Change of shut-off valves HE
Re-Design of Mini HE- series

Project No
225208

Project Title
Re-Design of Mini HE-
series

Date
03 December 2019

Previous Version	Future Version
 <i>Old rotary knob</i>	 <i>New rotary knob</i>
 <i>Old housing design</i>	 <i>New housing design, notice lack of protusion</i>

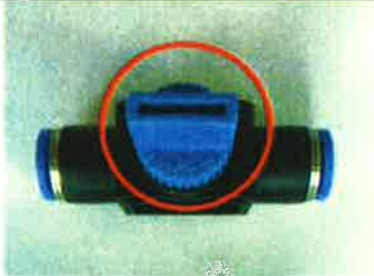
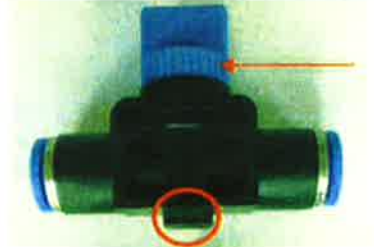
Due to a necessary replacement of the injection mold at our supplier, the HE mini shut-off valve series must be adapted. We therefore intend to change the design of the housing of these valves.

The change affects appearance of the product due to a differently shaped rotary knob and changed dimensions of the housing. Additionally, certain variants with threaded connectors will have a smaller wrench size. Positions and dimensions of the mounting holes stay the same.

- **Function**
Currently no known implications.
- **Environment**
Currently no known implications.
- **Interfacing**
Minor effects possible, see pictures and description above. Additionally, a smaller wrench is necessary to tighten connections on certain variants with male thread.
